Meeting Agenda

Franklin Municipal Planning Commission

Thursday, September 24, 2015

C 1.0

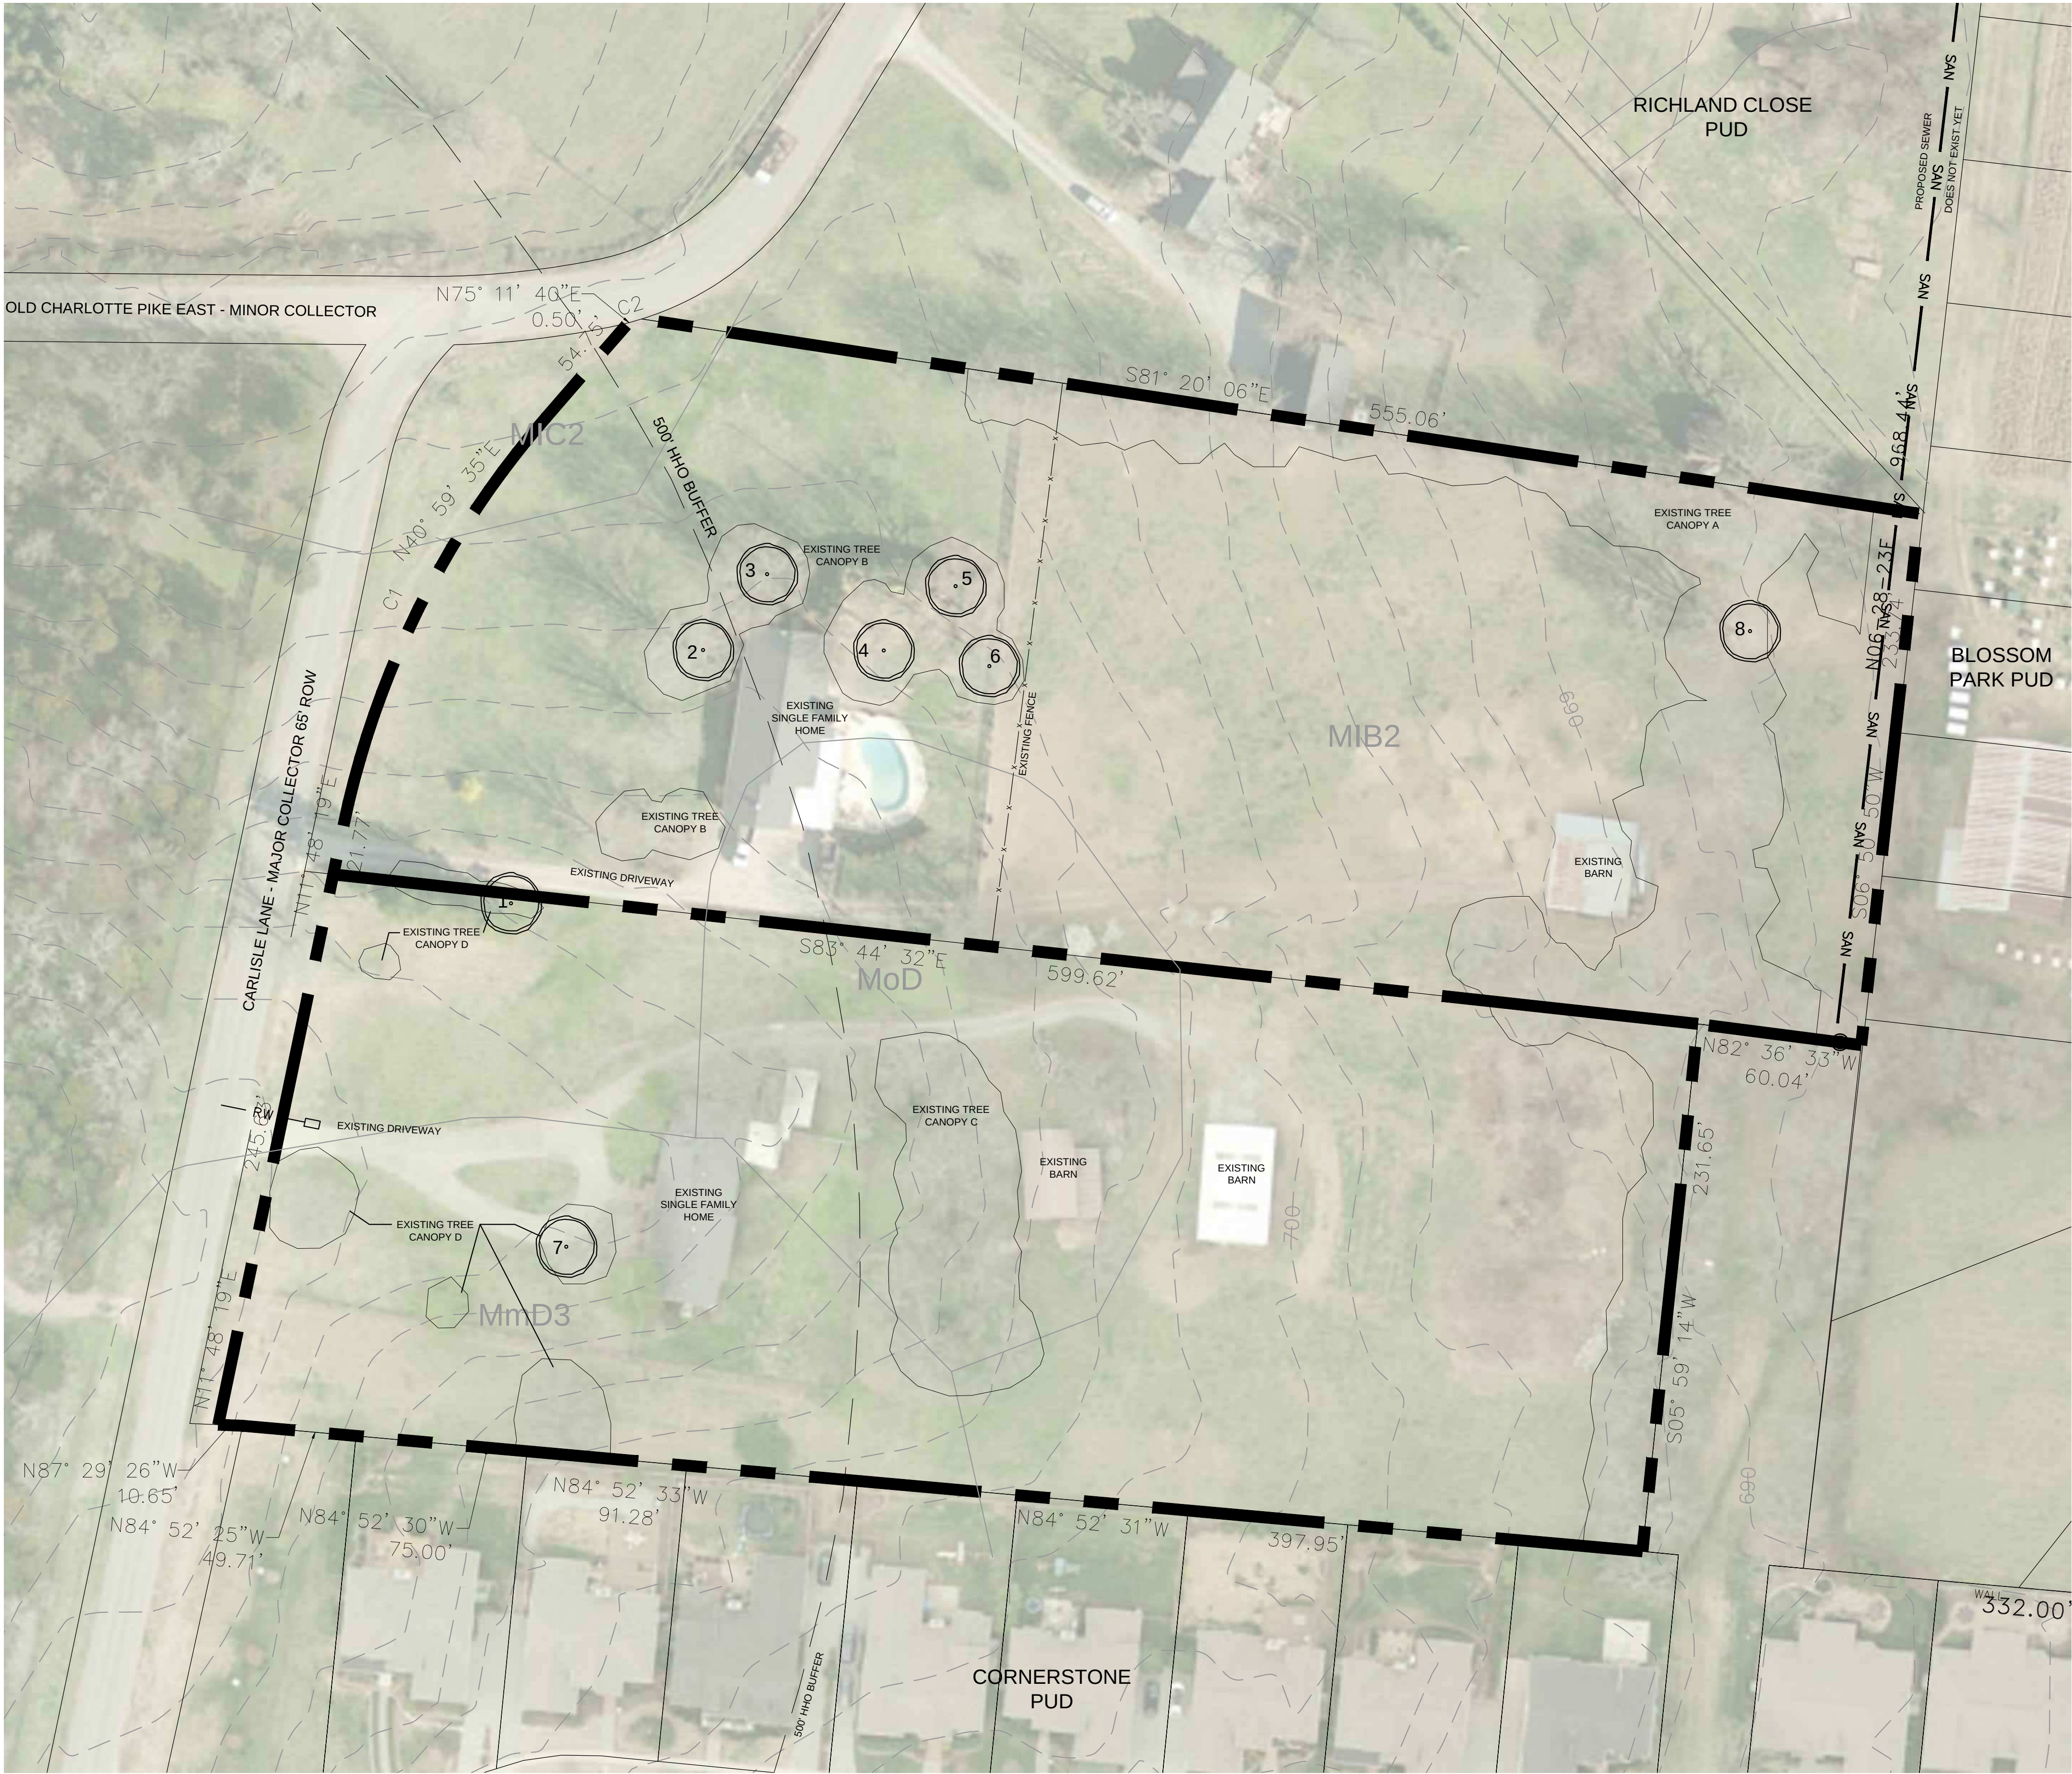
1. C1.0 - Overall Existing Conditions Plan

- Comment was not addressed. Applicant shall include a Stormwater Narrative recounting how stormwater is currently handled prior to exiting the site, prior to the proposed development, soil types, vegetation, flowtype, etc on the Overall Existing Conditions Plan.

2. C1.0 - Overall Existing Conditions Plan

- Applicant did not address the comment: Applicant shall include the standard Grading & Drainage Data Chart (available on Engineering's Development Services Webpage) on the existing conditions plan for undeveloped stormwater conditions.

3. C1.0 - Overall Existing Conditions Plan

- Applicant did not address the comment:

Applicant shall add more labels to contours. Add flow arrows to show direction of flow on existing conditions plan.

4. C1.0 - Overall Existing Conditions Plan

- Applicant did not address the comment: Applicant shall clearly delineate existing drainage basins with flow arrows, outfall locations with ID & elevation. Applicant shall include standard drainage data chart for each outfall on existing conditions plan.
